Field Memo Report

To: Mr. Bob Schatz (Atkins Architecture)
From: Jason Stanek, PE
CC:
Date: November 29, 2011
Re: 11-049 Atkins Remodel and Addition

ATKINS RESIDENCE

BASEMENT FLOOR PLAN WITH FLOOR FRAMING ABOVE

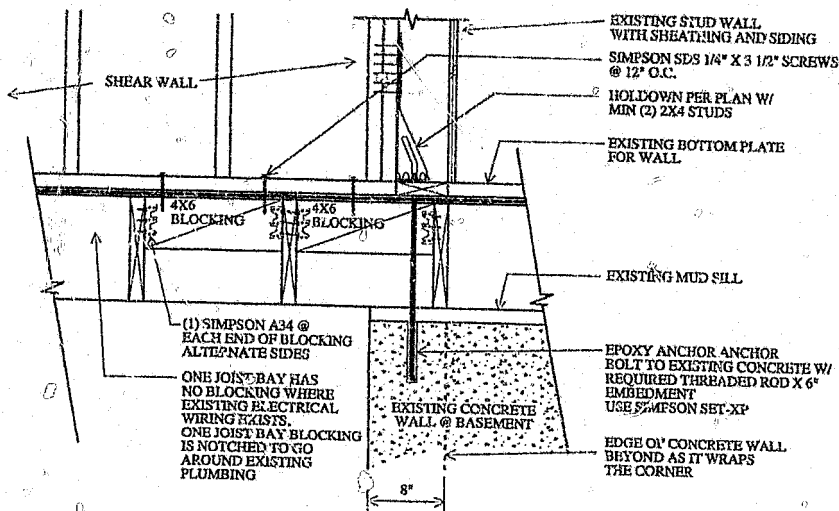
Question: During the preparation to begin the installation of the new shearwall sheathing on the existing hallway wall, we discovered that the steel wide flange beam that we initially thought was located directly under this location is instead located under the wall on the opposite side of the hall. We would like to keep the shearwall in the location that we are showing it now, however this changes the configuration of the lateral force transfer (no beam there to transfer loads over in to the existing concrete basement wall), and we now need to have the holdown anchoring in to blocking between existing joists. What do we need to add to make this configuration acceptable.

Answer: It appears that it will be acceptable to keep the shearwall in the current location, however we will need to add blocking under the wall in order to get our wall bottom plate anchorage down into the floor system. We will also place one holdown anchor rod down through blocking with oversized washer and nut, and attach the blocking to the 2 adjacent joists with Simpson brackets, and the other holdown appears to be capable of being installed in to the top of the existing concrete basement wall. This configuration assumes that the existing wood diaphragm transfers the lateral load over to the existing concrete wall. Through the connections of the sheathing to the continuous rim joist and end nailing of the rim in to the end of the joists and toe nails of the joists in to the mud sill, and finally, anchor bolts into the top of the concrete wall, the lateral load is transferred down where it is intended to go. Please refer to the attached plan of this area with additional information and details of the required revisions. Please also refer to the calculations attached herewith for the

revised shearwall length and holdown verification, as well as uplift calcs on the existing joists, diaphragm shear etc. for adequacy to drag the required loads.
